#2020-165

WK Building and Development Inc.

Project Review for Planning and Zoning Commission

1. Final Planned Unit Development Amendment to construct two duplex units.
2. Final Plat of Resubdivision creating a two-lot subdivision for Lot 110

FINAL PLAT
OF
ASHTON POINTE DUPLEX SUBDIVISION

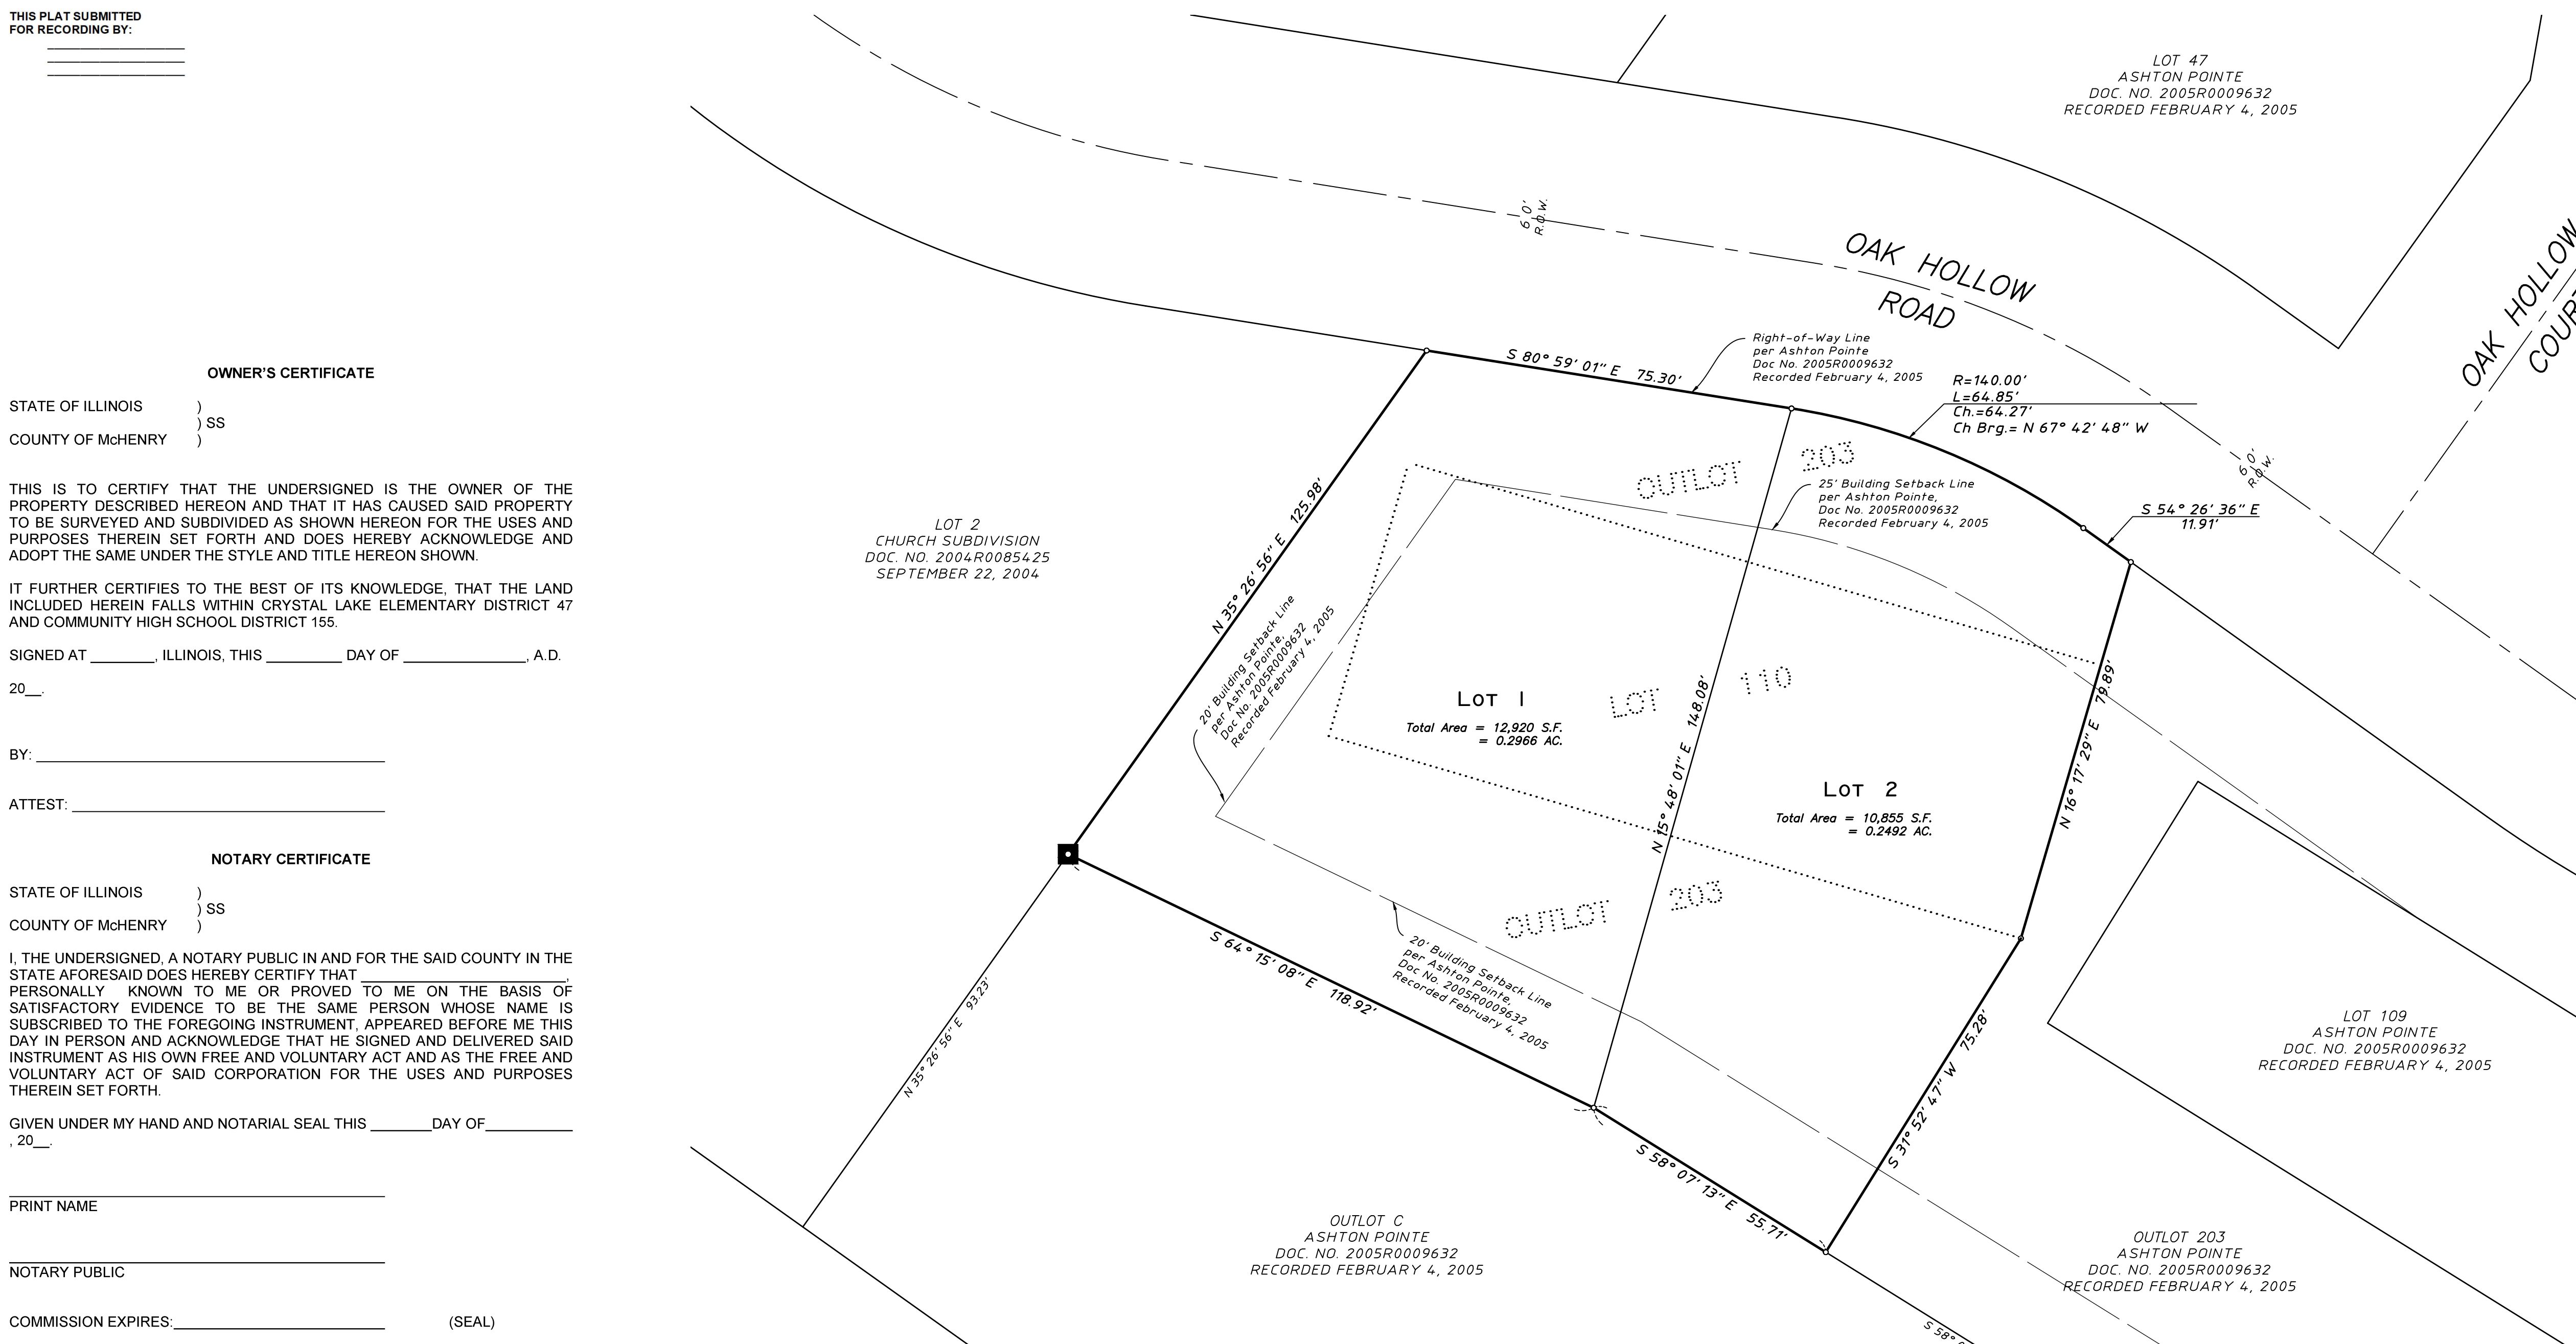
2. Plat of Subdivision document
 - A. Insert the school districts certification block on the plat.
 - B. Correct the Planning and Zoning Commission signature block.

- C. Provide the amended CCRs reflecting this change for City review and approval before recording.
 - D. The sidewalk must be extended to the terminus of Oak Hollow Road with this development.

- E. Provide a parkway tree(s) if feasible, with the two duplexes.
 - F. Correct the plat document to include all the required notations (easements, roadway dedication status, etc.), as detailed in Section 5-200G3b Subdivisions of the UDO.
